One Victoria,

Great Ducie Street,
Manchester

Proposed Amendments

Comparative Drawing Study

13th Floor Plan - DAY Amendment

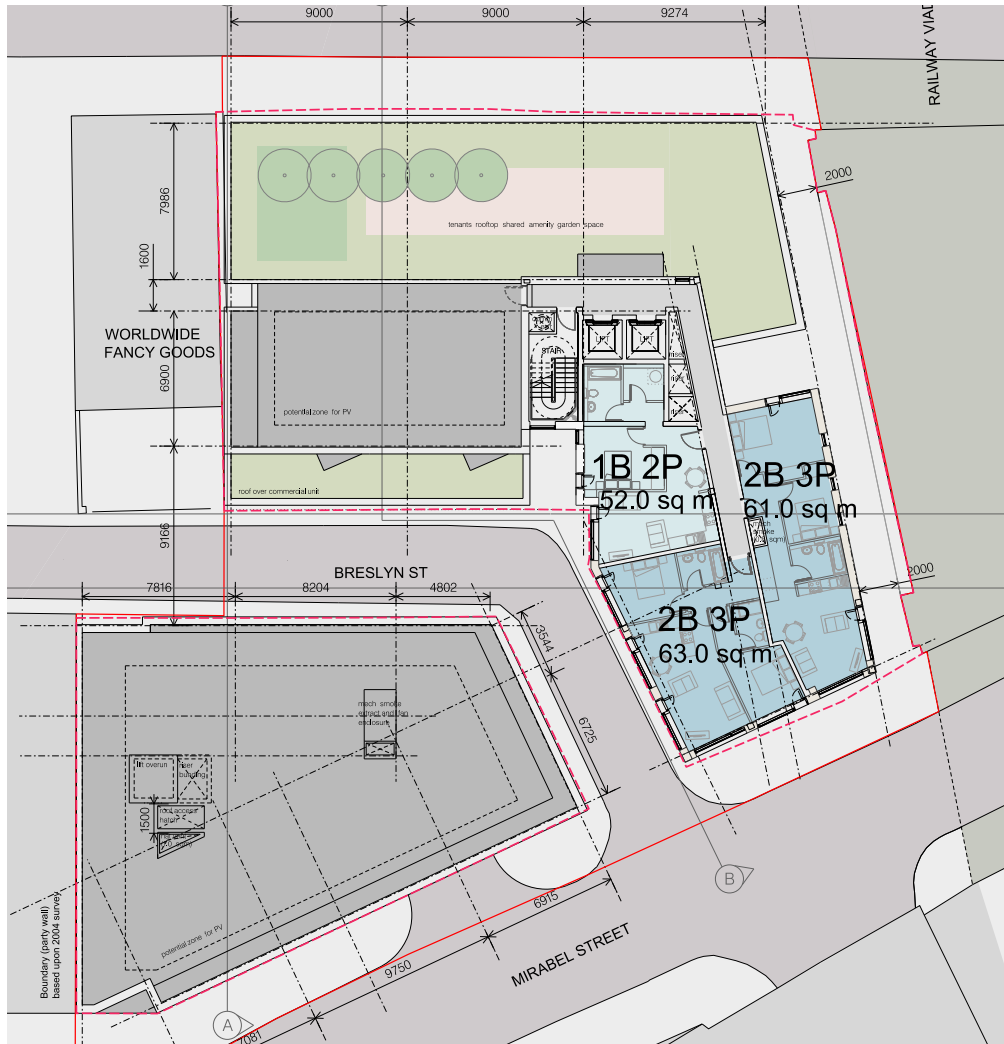
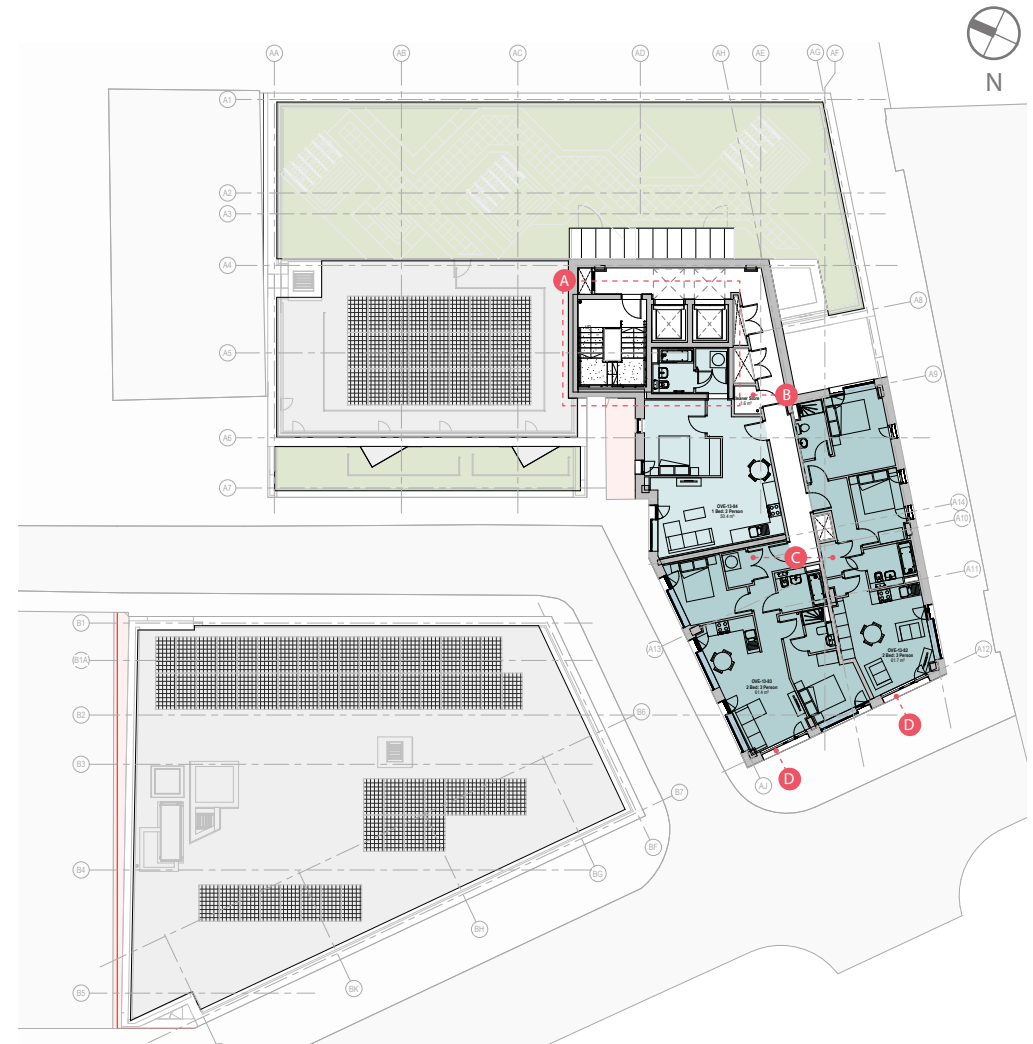
- A Core updated due to no-build zone
- B Riser changed to cleaner store
- C Apartment layout updated to include store / service cupboard
- D Window adjacent to bay now becomes a full height openable window unit with a dummy transom (for continuity)

Roof Plan - DAY Amendment

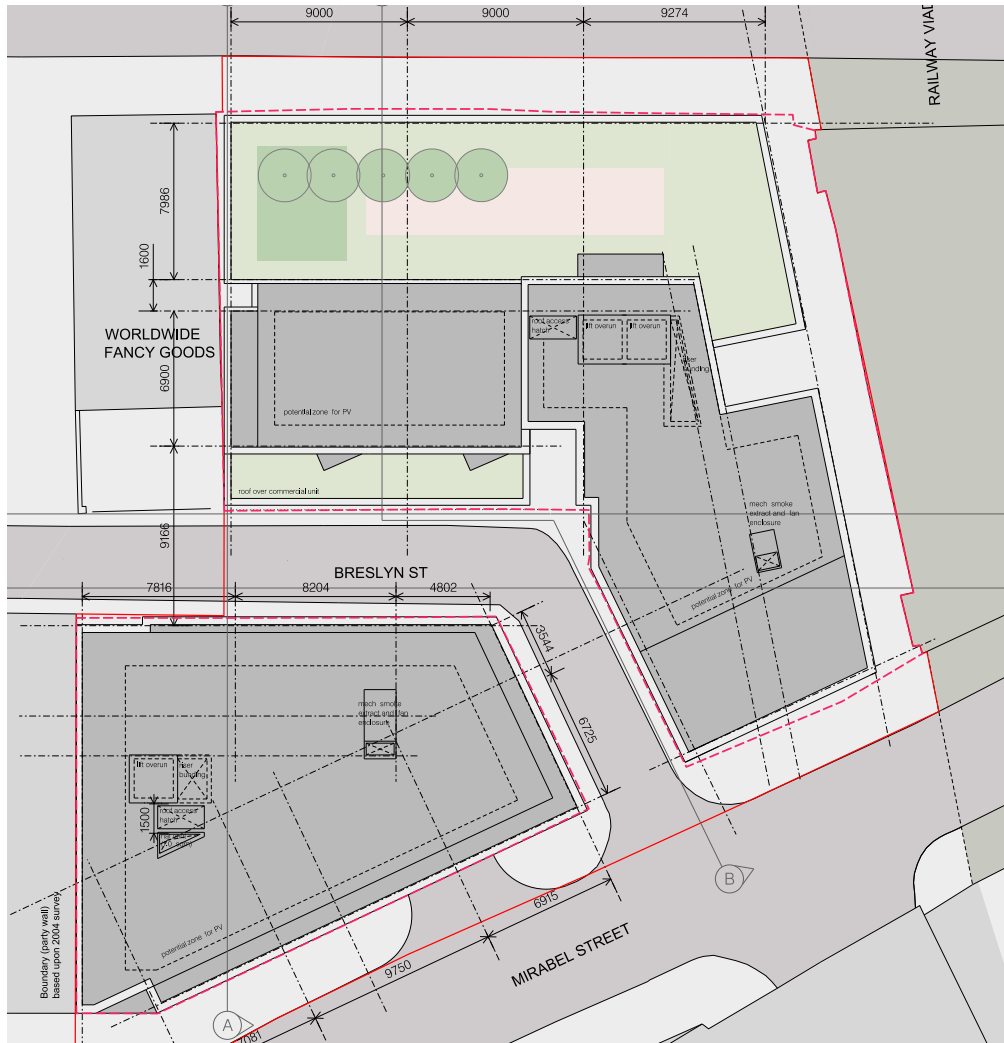
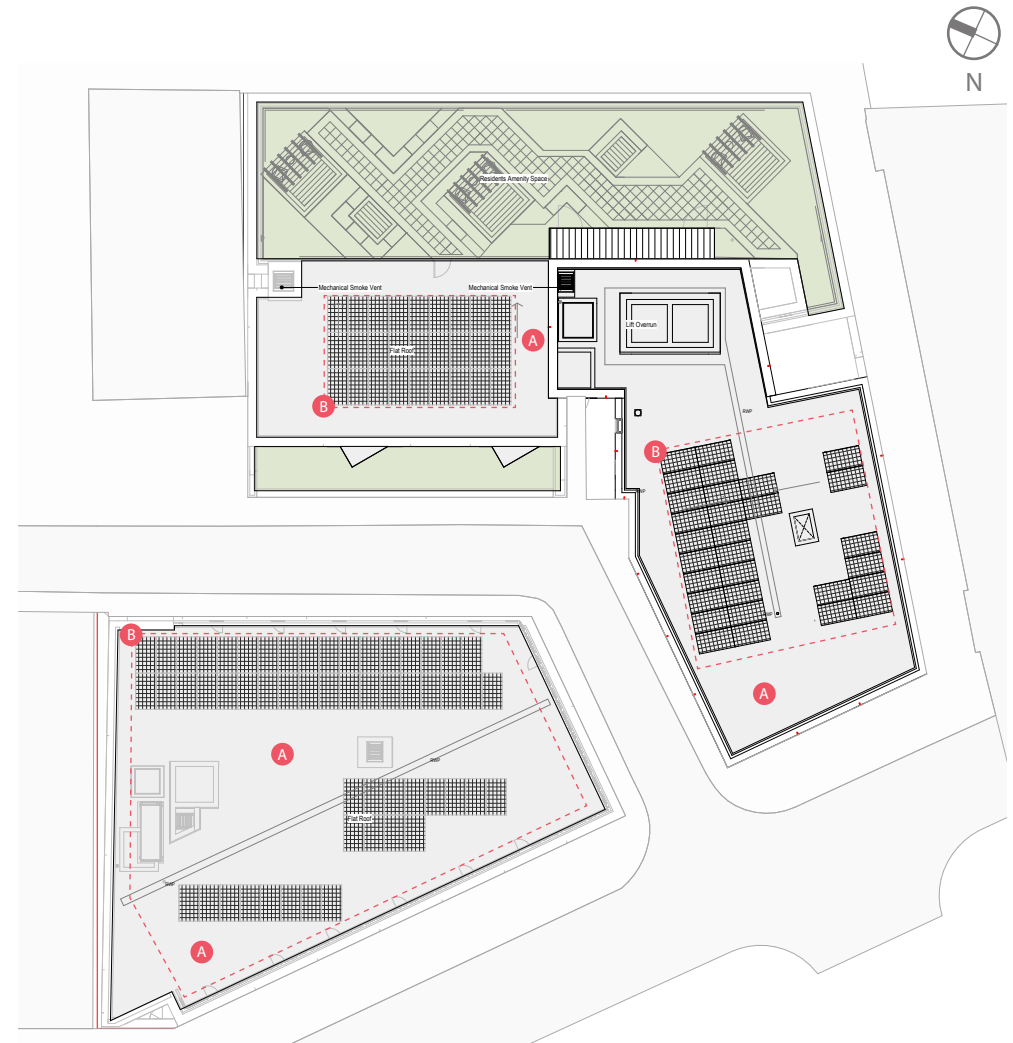
- A Additional Plant
- B PV to all plant area roofs

North Section AA Elevation - DAY Amendment

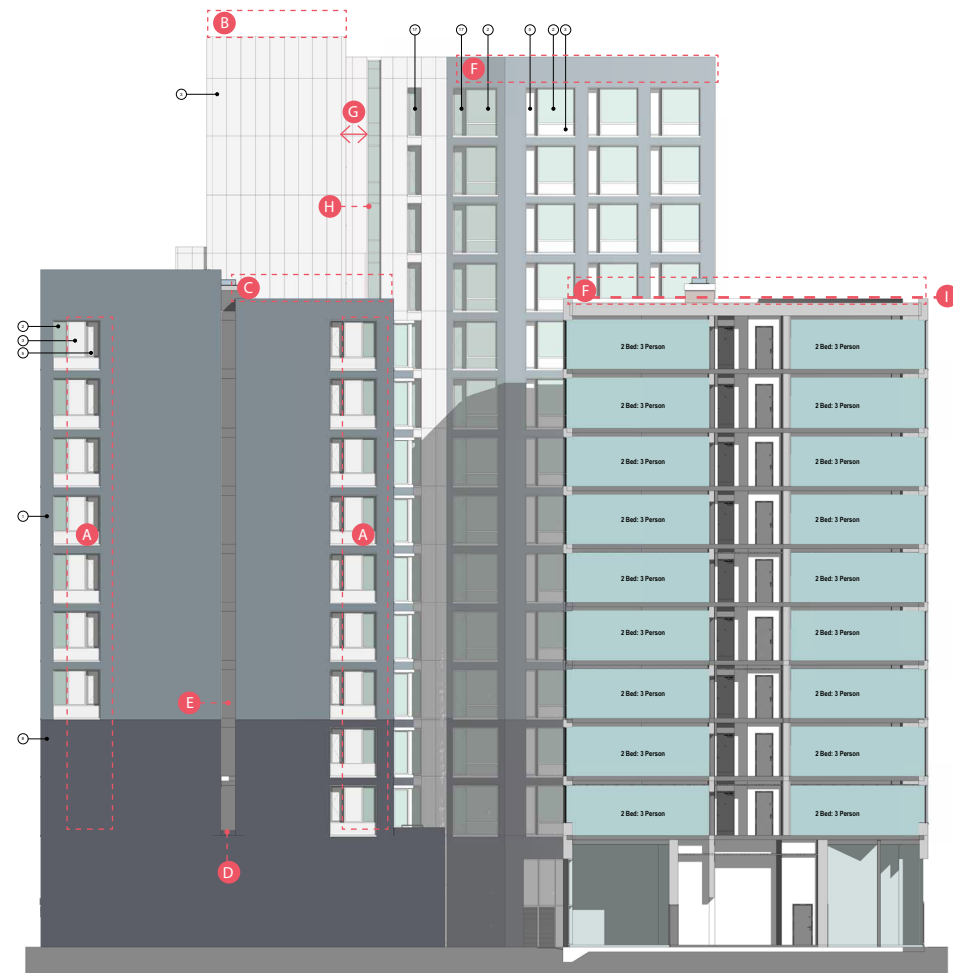
- A Window style to gable end amended to allow for 1m sq opening in line with fire regulations
- B Parapet reduced from 2m to 1.2m
- C Plant screen omitted
- D Width of split in facade reduced to 685mm (from 900mm) to align with brick dimensions
- E Changed to opaque glazed/aluminium spandrel curtain walling system. This is due to the requirement for a mechanical lift shaft
- F Plant screen omitted
- G Line of stair core pulled back to allow for no build zone. This introduces small extent of aluminium panel between the main stair core and the 14 storey tower
- H Window location retained as original design, shadows omitted for clarity
- I Parapet raised 150mm to allow for low level roof parapet

North Section BB Elevation - DAY Amendment

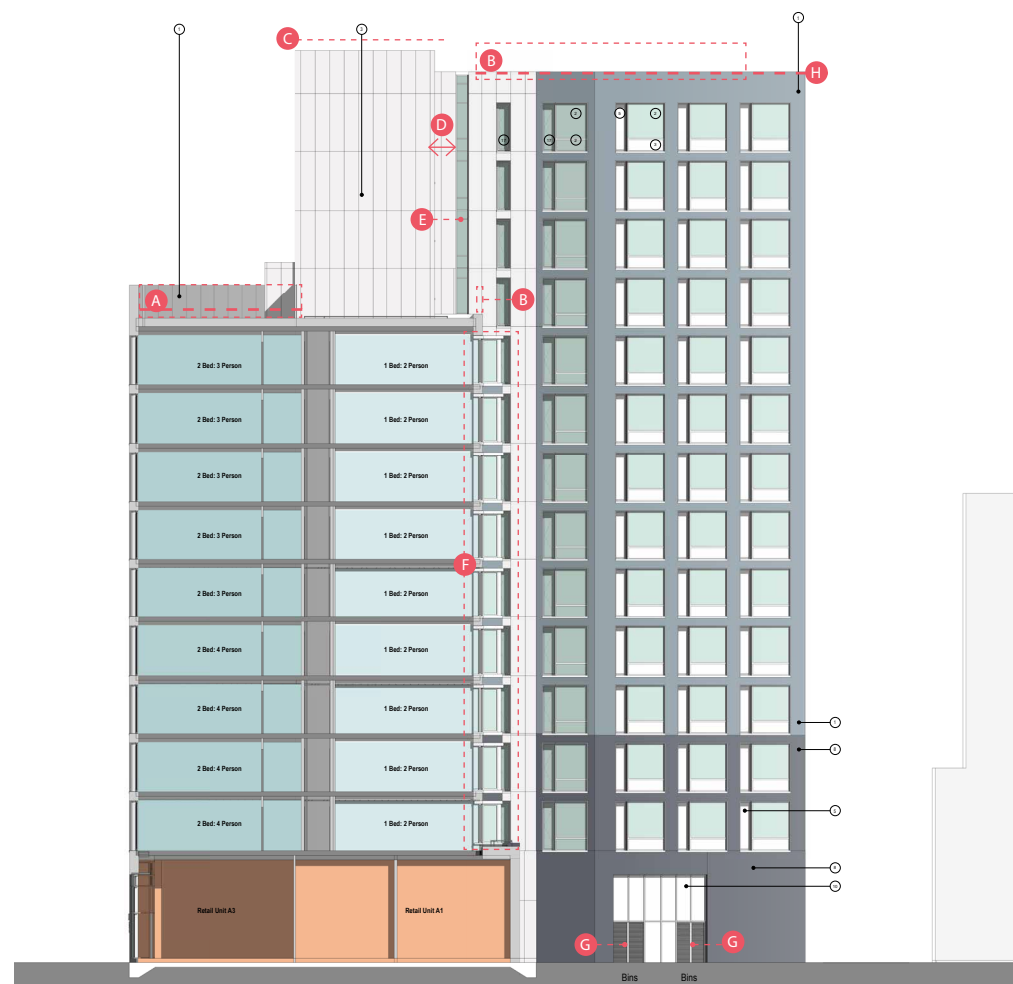
- A Omit screen and increase masonry parapet by 450mm
- B Plant screen omitted
- C Parapet reduced from 2m to 1.2m
- D Line of stair core pulled back to allow for no build zone. This introduces small extent of aluminium panel between the main stair core and the 14 storey tower
- E Window location retained as original design, shadows omitted for clarity
- F Flooring detail to feature sawtooth windows amended to provide masonry to follow profile of windows
- G Louvred doors added to bike and bin stores
- H Parapet raised 150mm to allow for low level roof parapet

East Elevation - DAY Amendment

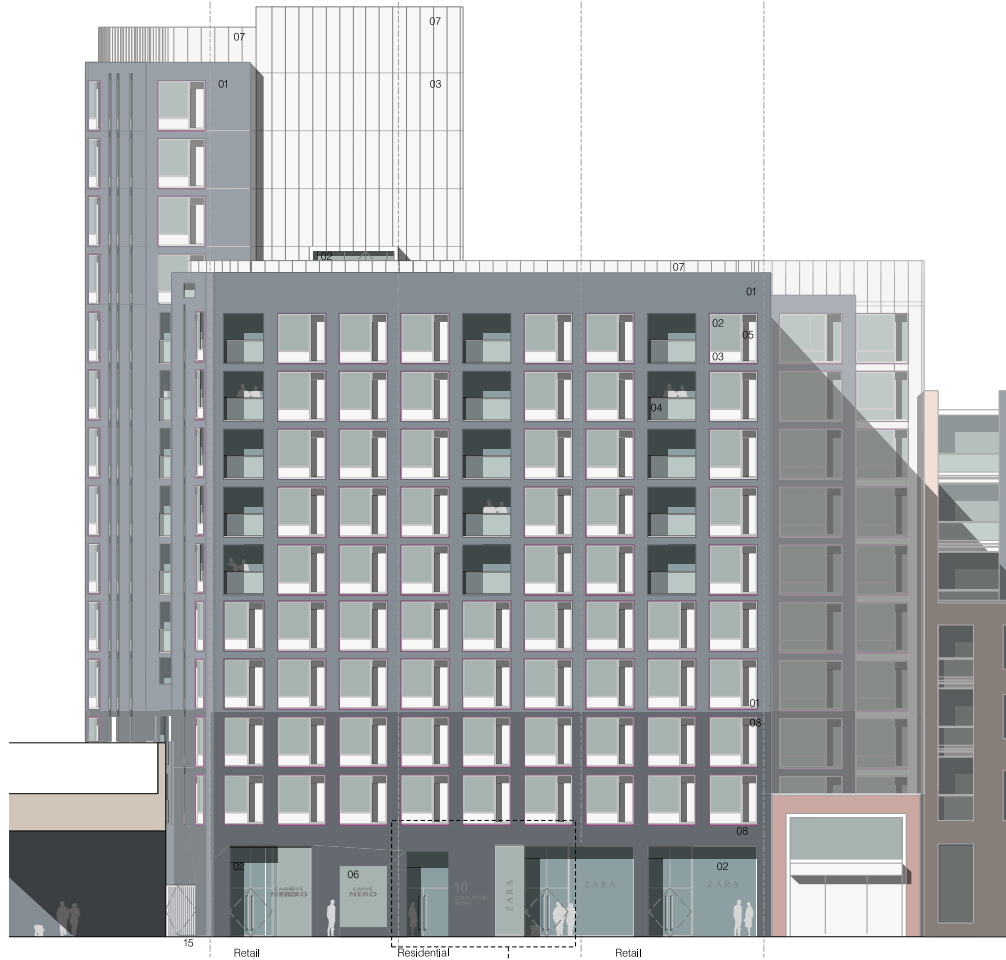
- A External accessible WC included for amenity space users
- B Plant screen omitted
- C Plant screen height reduced from 2m to 1.2m
- D Access to amenity space increased in width
- E Masonry parapet raised 450mm to provide 1650mm guarding in line with window safety requirements
- F Curtain wall grid shown
- G Louvred vents added
- H Double doors shown
- I Plant screen omitted to perimeter of roof
- J Parapet line raised 150mm to allow for low level roof parapet

East Section CC Elevation - DAY Amendment

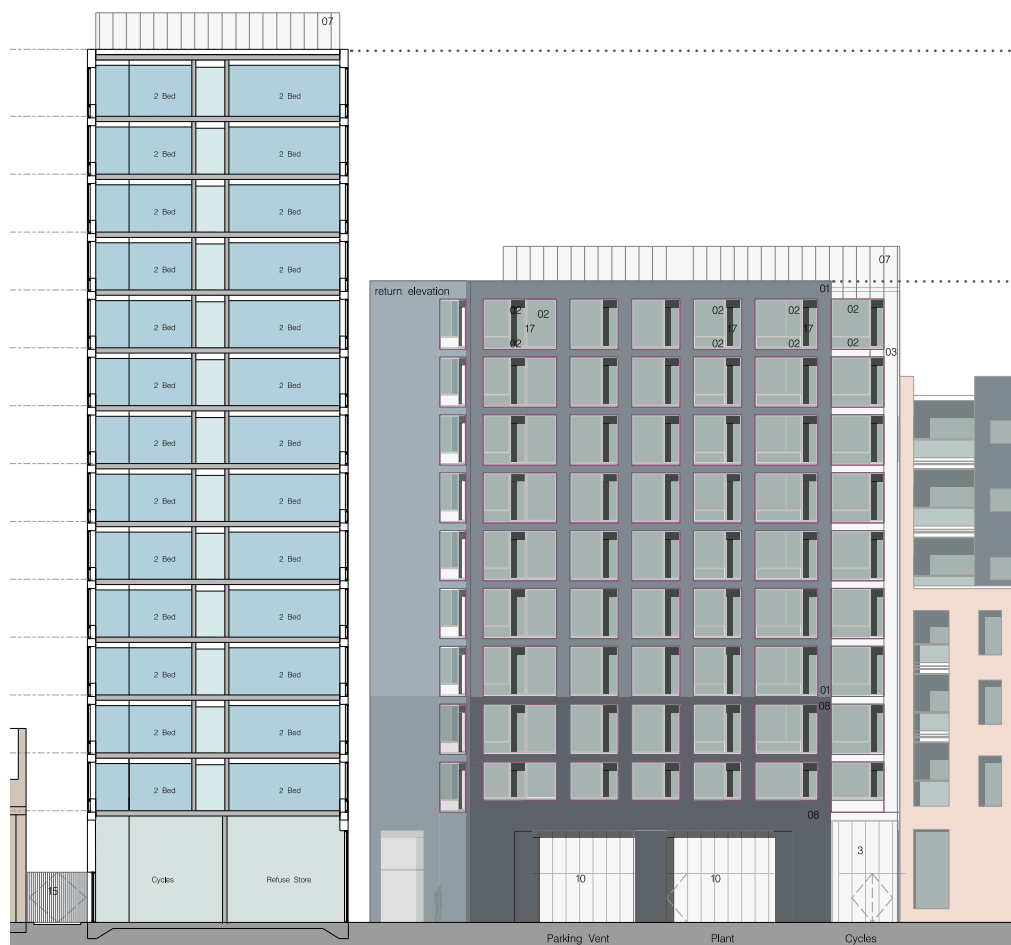
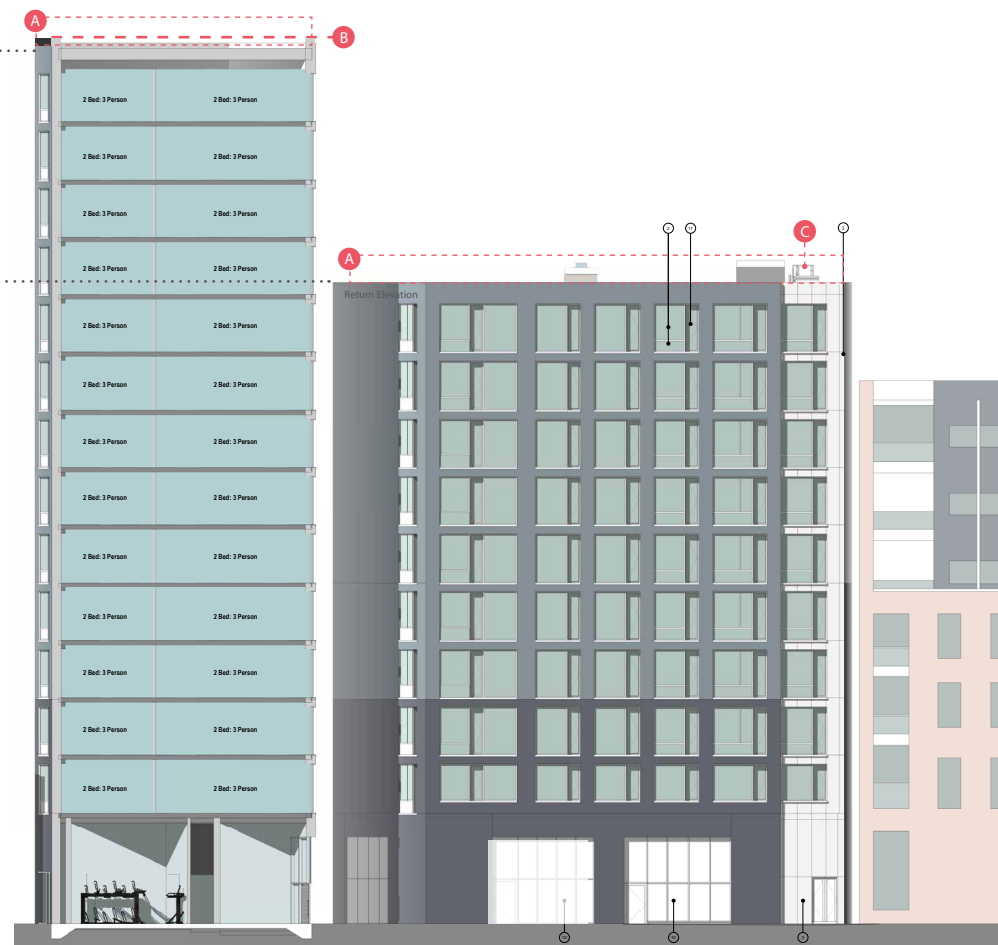
- A Plant screen omitted
 B Parapet line raised 150mm to allow for low level roof parapet
 C Lift over run and smoke shaft shown previously hidden behind parapet screening

South Elevation - DAY Amendment

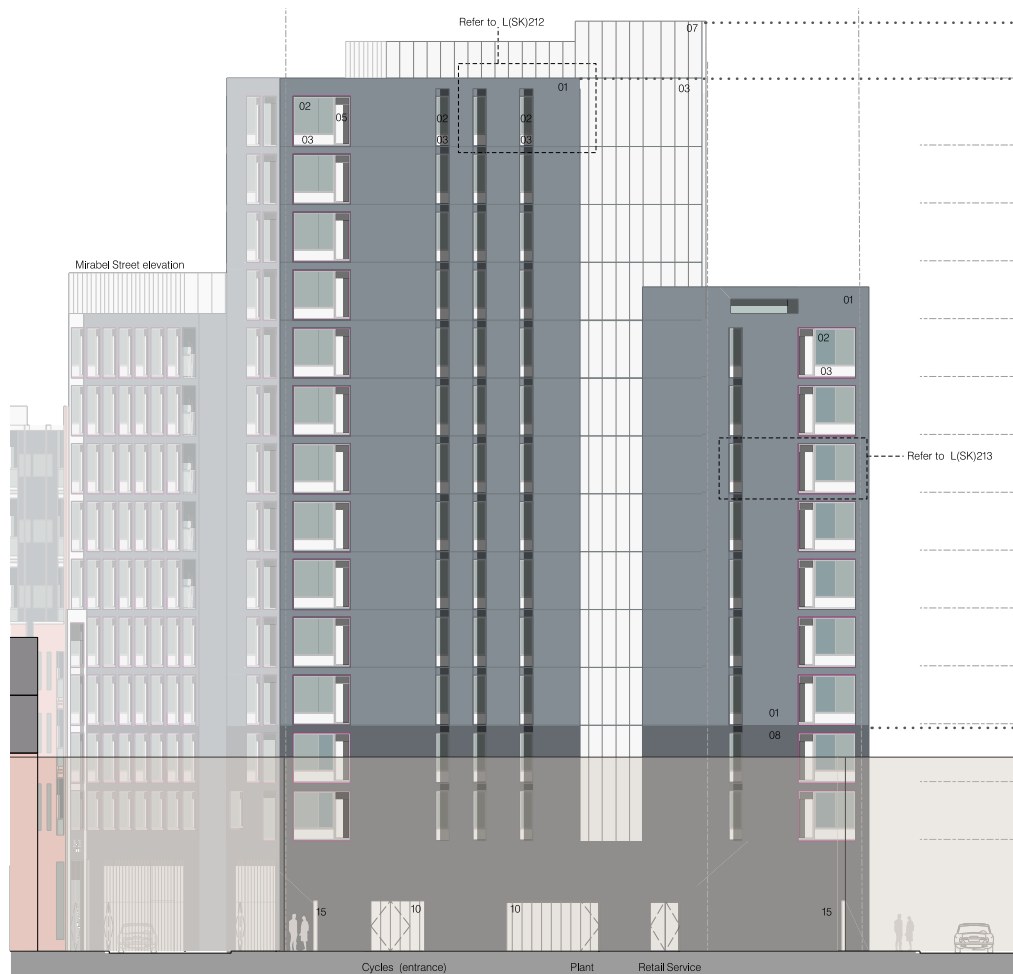
- A Plant screen omitted, parapet raised 150mm to allow for low level roof parapet
 B Parapet height reduced from 2m to 1.2m
 C Roof terrace access increased
 D Opening in parapet removed due to Network Rail requirement not allowing openings from over the viaduct
 E Transparent glazed balustrade increased to full height as per Network Rail requirement
 F Masonry parapet increased 150mm
 G Door omitted
